Proposed Residential Development  
Land at Chichele Road, Oxted

**Appendices to Proof of Evidence of Andrew  
Whittingham BSc (Hons), MSc, CEng, MICE**

Appeal Reference: APP/M3645/W/24/3345915

Stage 1 Road Safety Audit  
Prepared on behalf of Motion

Drawing: **1907029-TK01.1**      Revision: **C**  
 Page 40

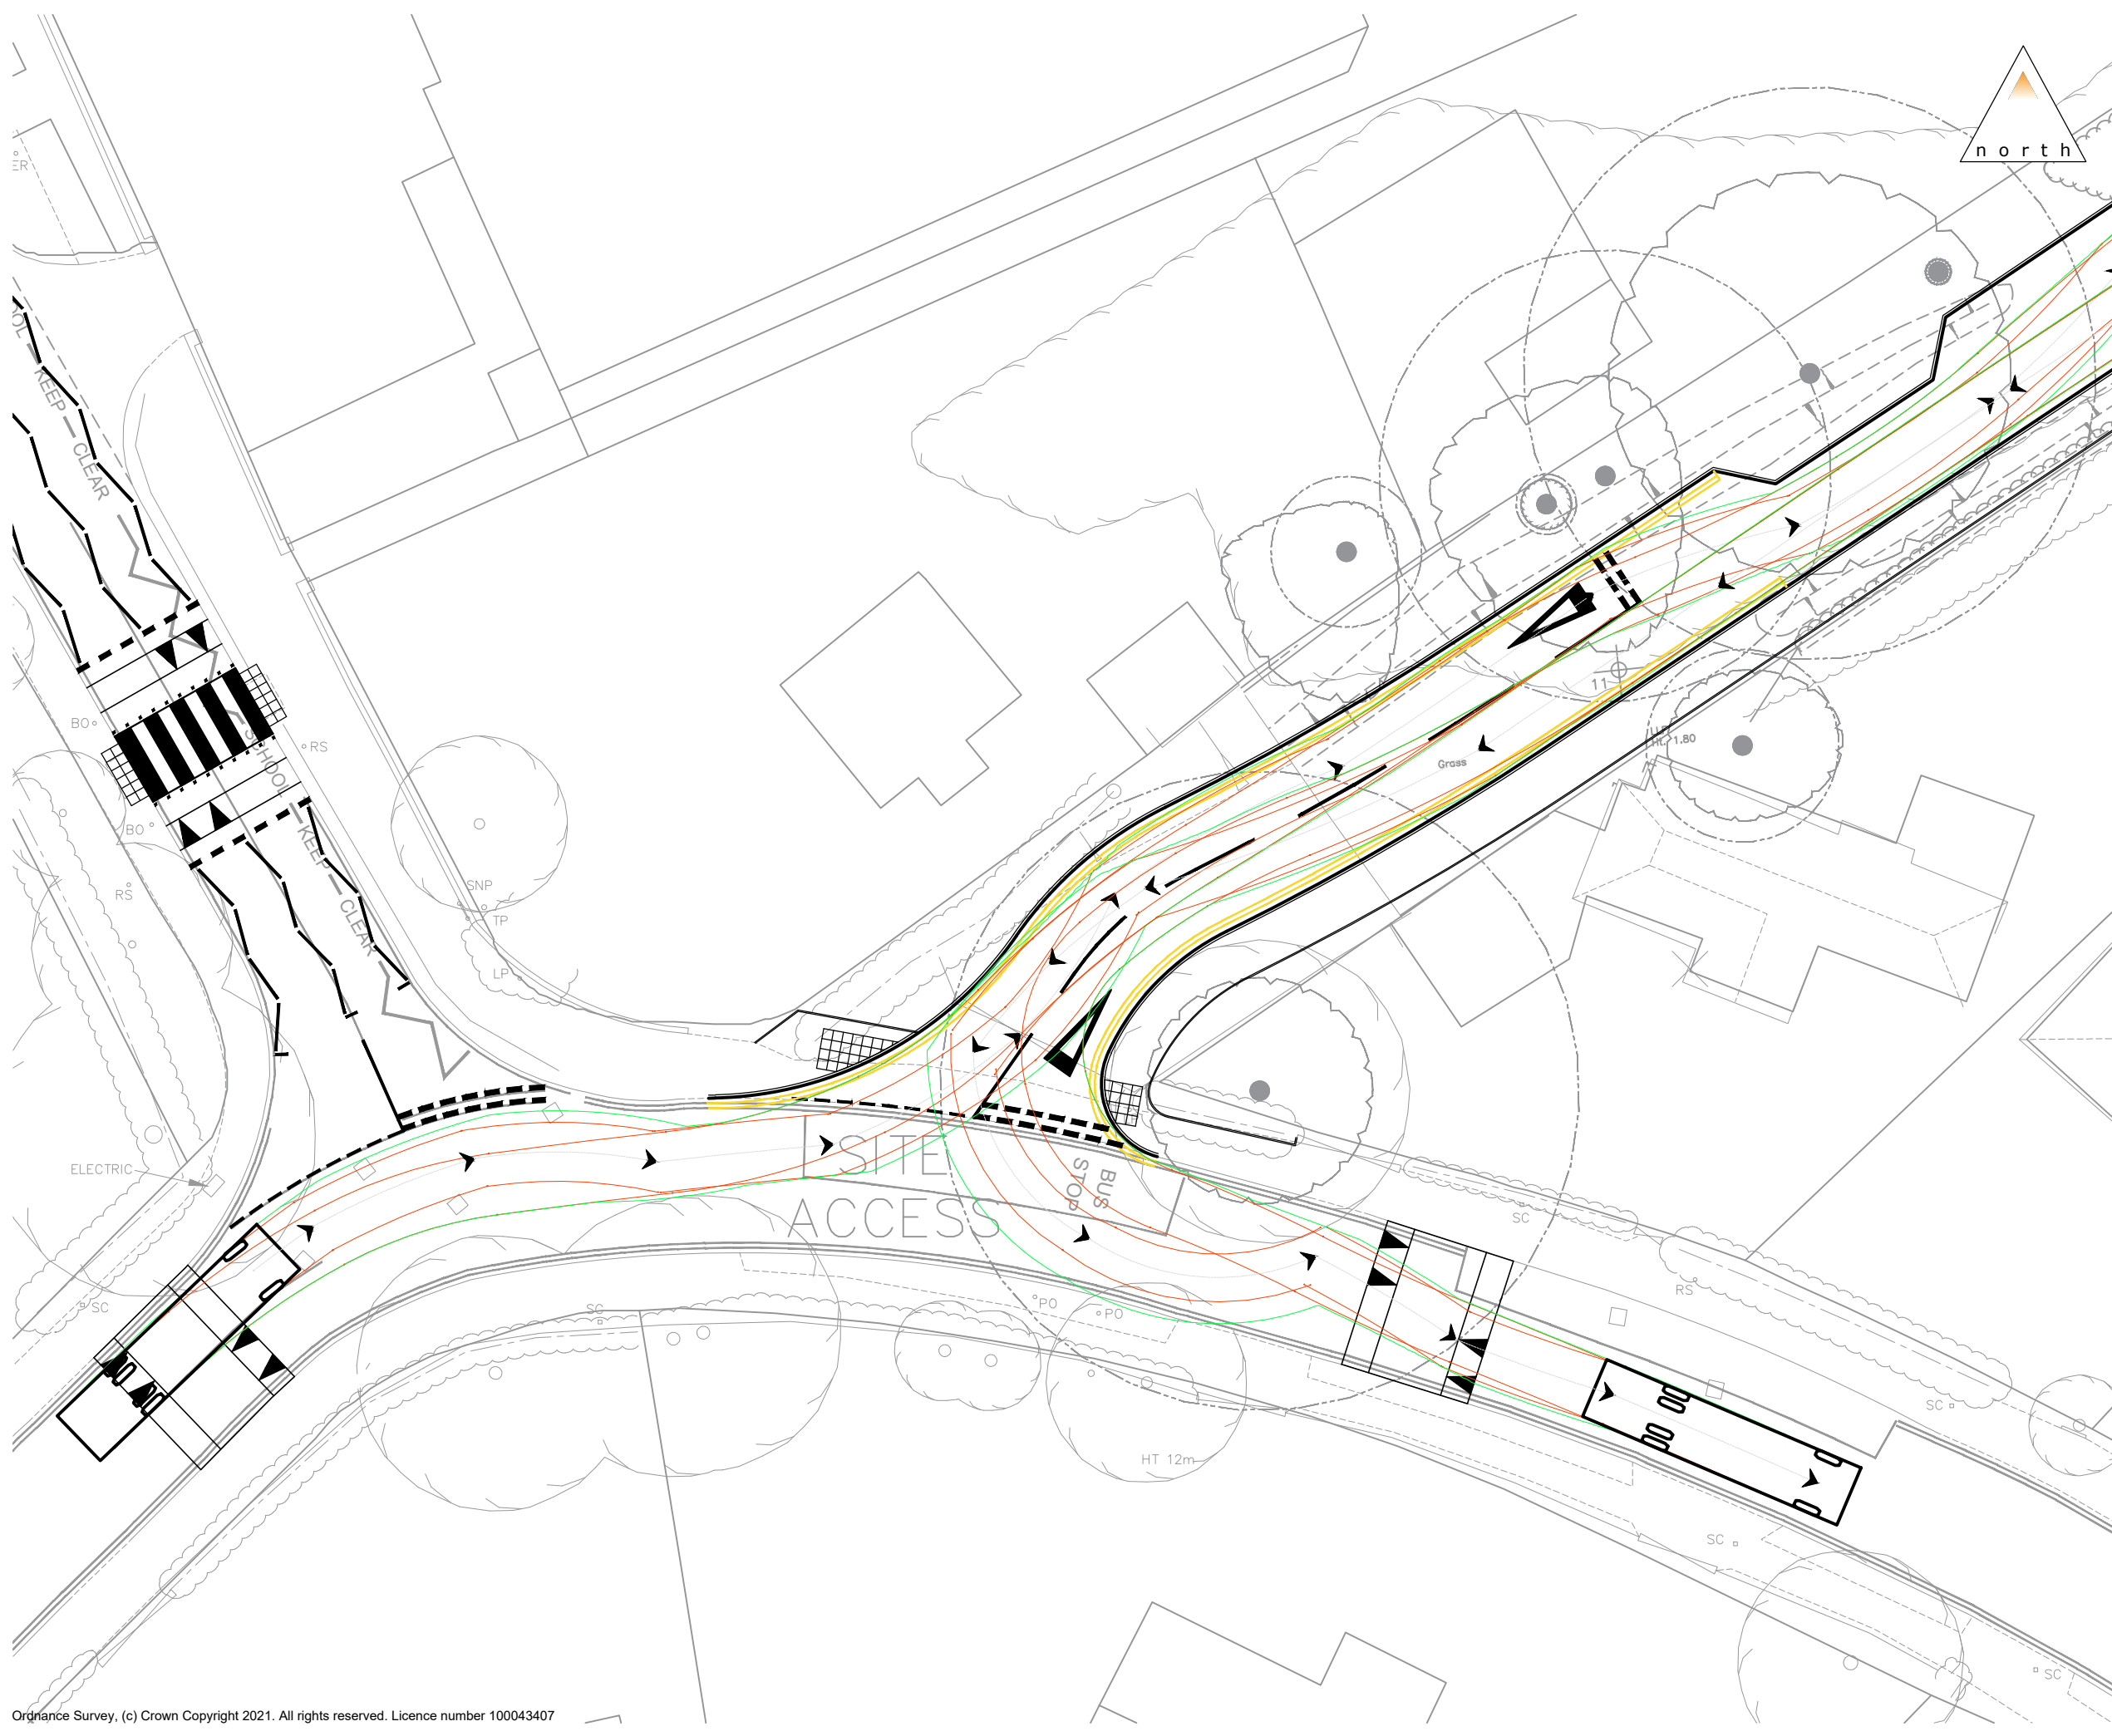
No vehicle swept path plots have been provided and it is not clear that service vehicles will be able to turn adequately to/from the site access. This may lead to reversing manoeuvres by large vehicles to/from the highway, increasing the risk of collisions with other road users.

Provide vehicle swept path analysis for service vehicles, demonstrating that they will be able to turn adequately to/from the site access.

2.2	Provide vehicle swept path analysis for service vehicles, demonstrating that they will be able to turn adequately to/from the site access.	Swept path analysis for a refuse vehicle has been undertaken to ensure vehicles can enter and exit the site.
